**License to Operate On-Site Sewage Treatment and Disposal Facility**

Issued This Date: 06/19/2019 Permit Number: 108468

Location Description: 1461 ACACIA PKWY  
SPRING BRANCH, TX 78070

\*\*\* COMAL COUNTY OFFICE OF ENVIRONMENTAL HEALTH \*\*\*  
APPLICATION FOR PERMIT FOR AUTHORIZATION TO CONSTRUCT AN  
ON-SITE SEWAGE TREATMENT FACILITY AND LICENSE TO OPERATE

# Cypress Springs Unit 1

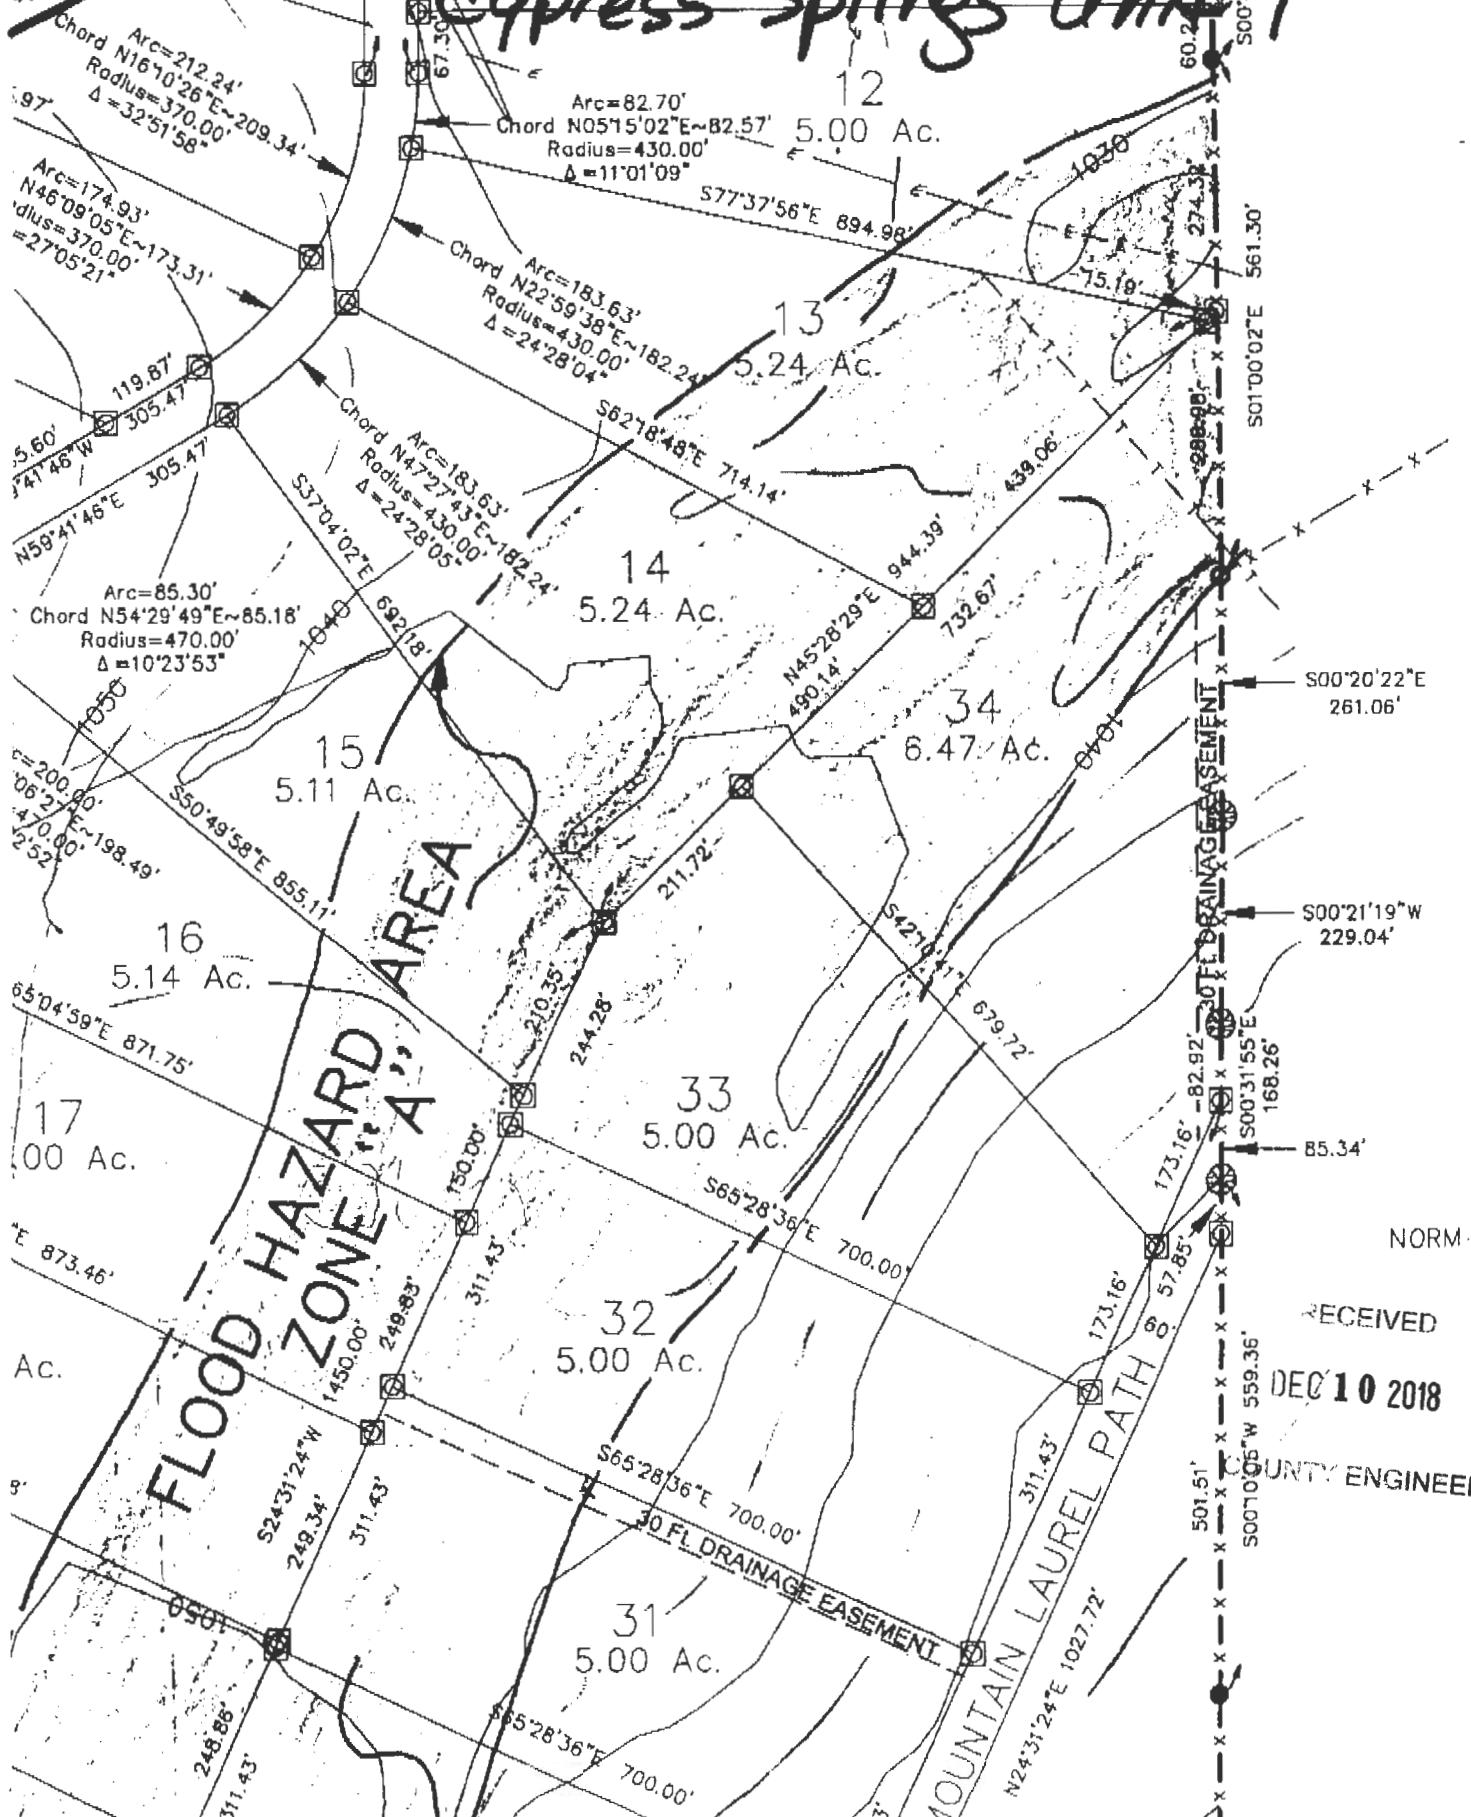
We received planning materials for the referenced permit application on December 6, 2018 and found those planning materials to be deficient. In order to continue processing this permit, we need the following information:

1. Submit a signed site and soil evaluation form.
2.  Include the detached living area on the permit application.
3.  Indicate the distance from the driveway to the first trench.
4. Indicate the distance from the well to the OSSF system components.
5.  Show the waterline location to the main house and detached living area.
6.  The length of the trench closest to the driveway appears to longer than 43.75.
7. Revise accordingly and resubmit.

Lot 14 Cypress Springs  
detail of septic area

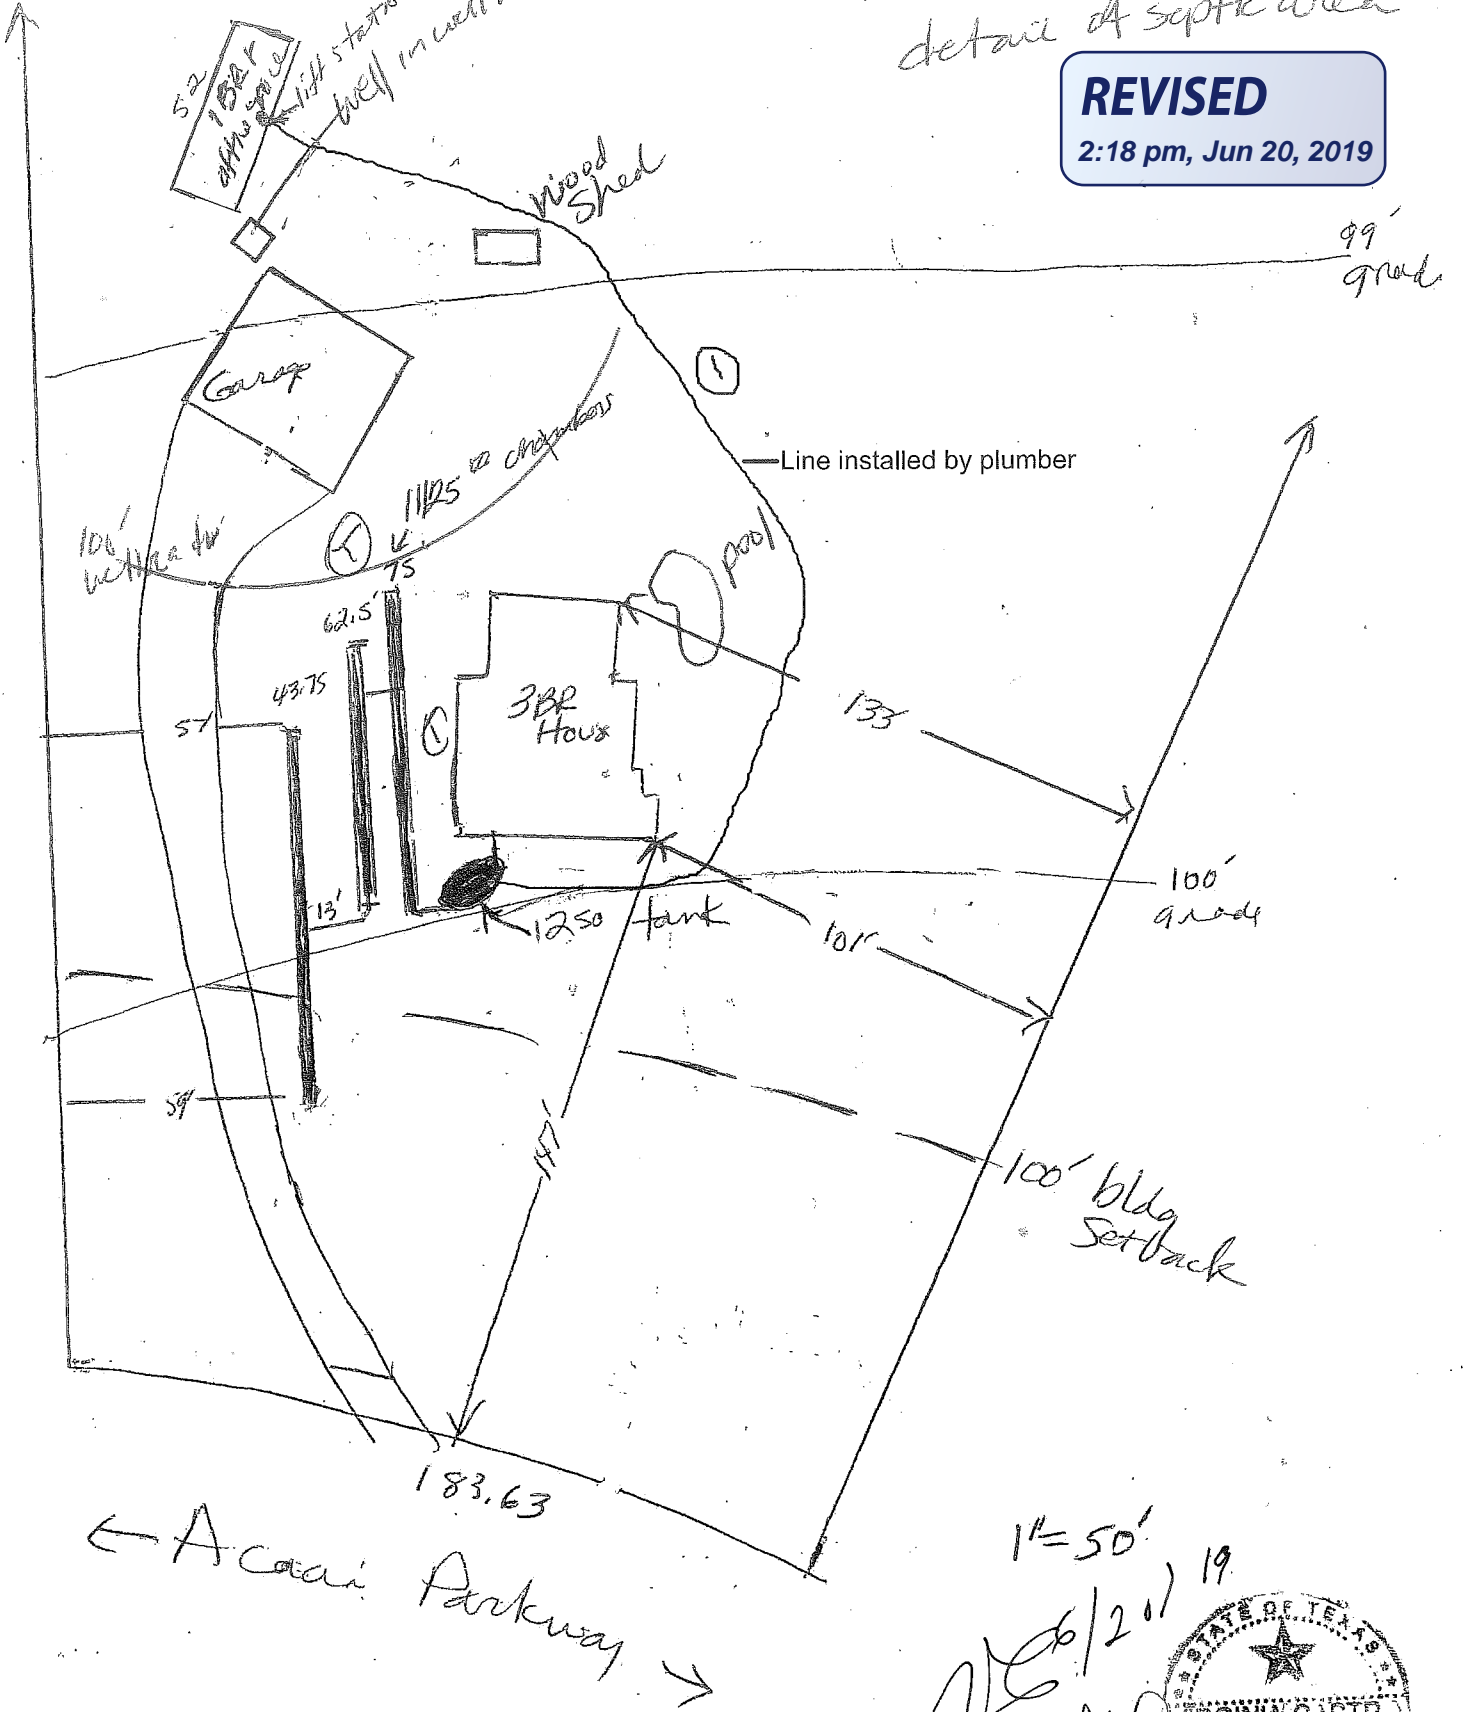
We received revised planning materials today, but still need the following information:

1. The site and soil evaluation form that was submitted with the planning materials is not signed.
2. Indicate the square footage of the detached living area. *936<sup>sq</sup> already included on*
3. Show the distance from the well to the tightline. *total on permit*

This is Mr. George's correction with the missing notes added. (He says the pump which the plumber installed never crossed a water line or a septic line.) Virginia

Lot 14 Cypress Springs  
detail of septic area

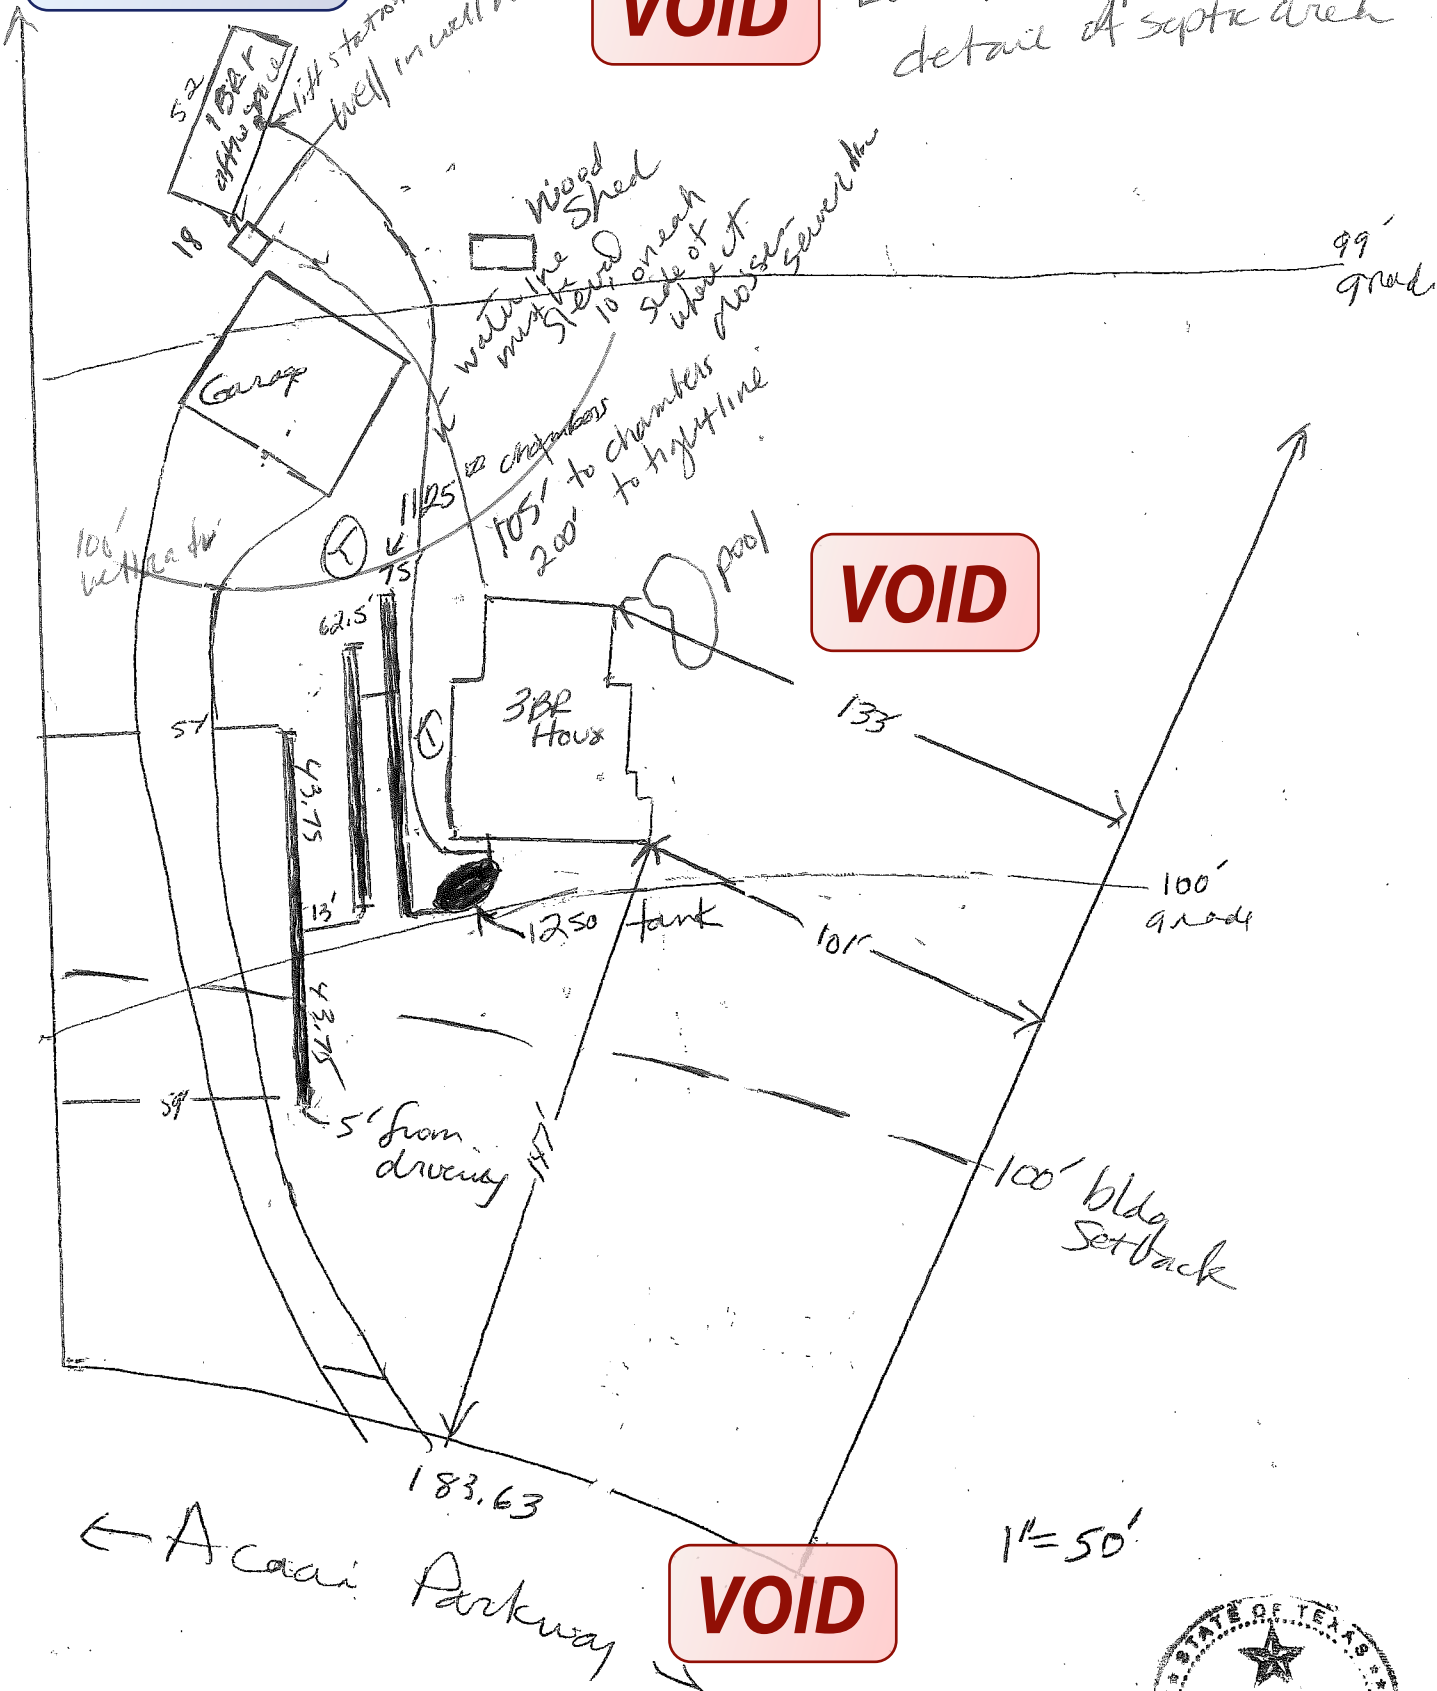
We received revised planning materials today, but still need the following information:

1.  The site and soil evaluation form that was submitted with the planning materials is not signed.
2.  Indicate the square footage of the detached living area.
3.  Show the distance from the well to the tightline.
4. Revise accordingly and resubmit.

I drew in the original system as it was installed, and added the new detached living area, thus I included the measurements ( it was not 43.5 the entire length, but 43.5 on either side of the connecting pipe, thus a total of 87 feet, which is why the last trench looks so long) I included Greg Johnson's soil report as the soil has not changed nor the leach field! I made the other corrections as you requested. Sincerely, Virginia
